Tender FAQs from Question n.1 to Question n.54

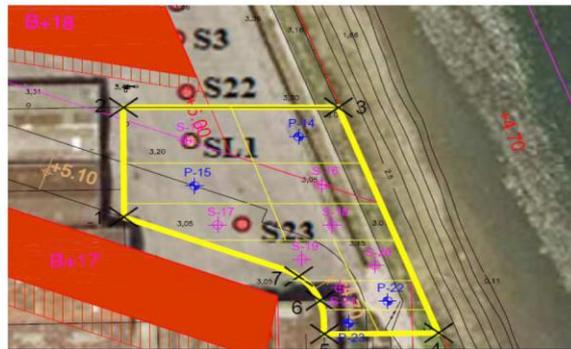
- 51.1 Page 26, Figure 177. The name of the sampling points is not clear. Could you provide a better resolution image?
- 51.2 Piezometers on Figure 166 (page 23) and Figure 177 (page 26). We would like to know the depth of each piezometer and a geological description.
- 51.3 Page 27. Results of soil chemical analysis. We would like to know the depth of each sample and the location of the sampling points.
- 51.4 Page 28. Results of groundwater chemical analysis. We would like to know the location of the sampling points.

51.1 Please [click here](#) to download a high-resolution version of Figure 177
